Product change notification (PCN)

Title / short description	Semiconductor replacement with updates to technical characteristics within the DEK series
Affected article category	Relay modules
Change category	Characteristics, Function
Change number	CDK250027-00
Reason for PCN/PDN Revision

CDK250027

Semiconductor replacement with updates to technical characteristics within the DEK series

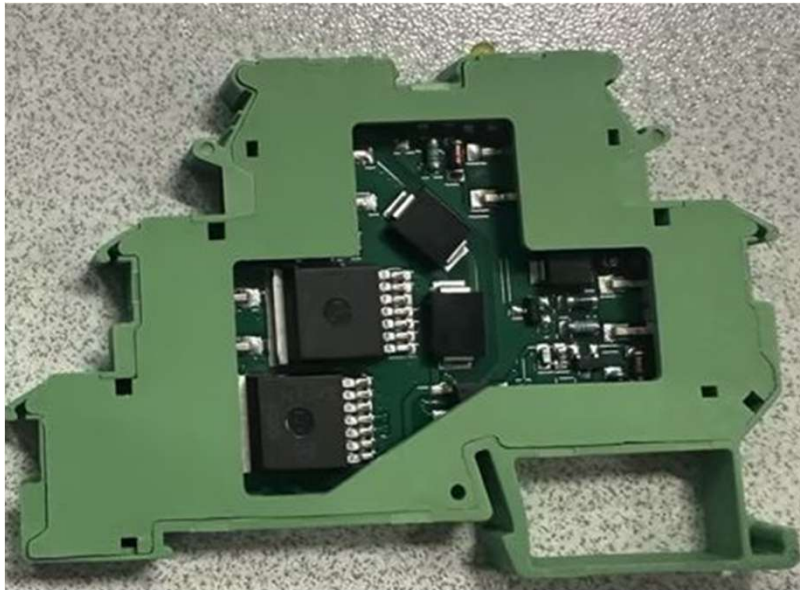
This change concerns three articles within the DEK series (see list). The existing semiconductor has been discontinued and will be replaced by a new, functionally suitable semiconductor type. As a result, minor adjustments to technical characteristics. All updated technical data as well as the revised product appearance are included in the attachment.

Additionally, the previously implemented milling/cutout in the product housing will be removed, as it is no longer required with the new component. All existing approvals and conformity certifications remain valid and unchanged for the affected items.
